Updated
HARNETT COUNTY CENTRAL PERMITTING
APPLICATION # BRES1907-0027
JOB NAME Atvarez
DATE PLANS RECEIVED 7.18.19
SITE PLANS APPROVED _____
APPROVED BY _____

15 Curragh Cove
PATIO ROOF

FRONT
ELEVATION

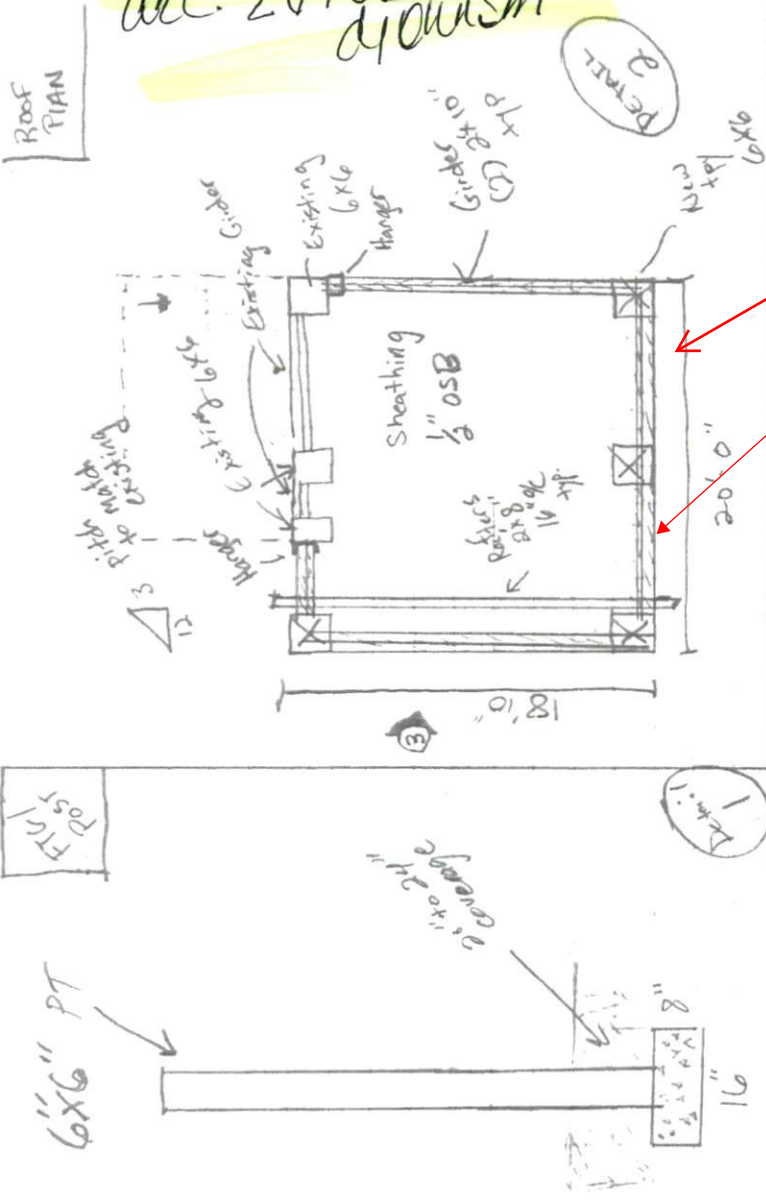
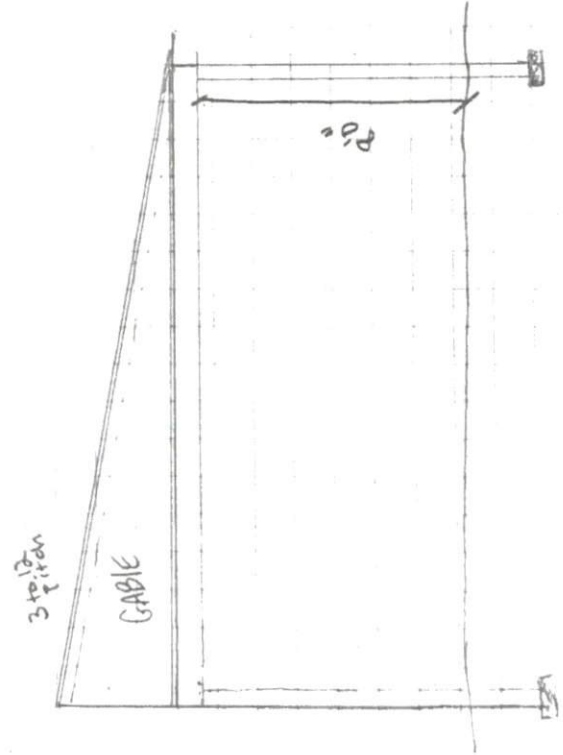
Per customer size of
headers supporting roof
acc. 2v10
diagrams

headers here must be 2-
2x12 minimum
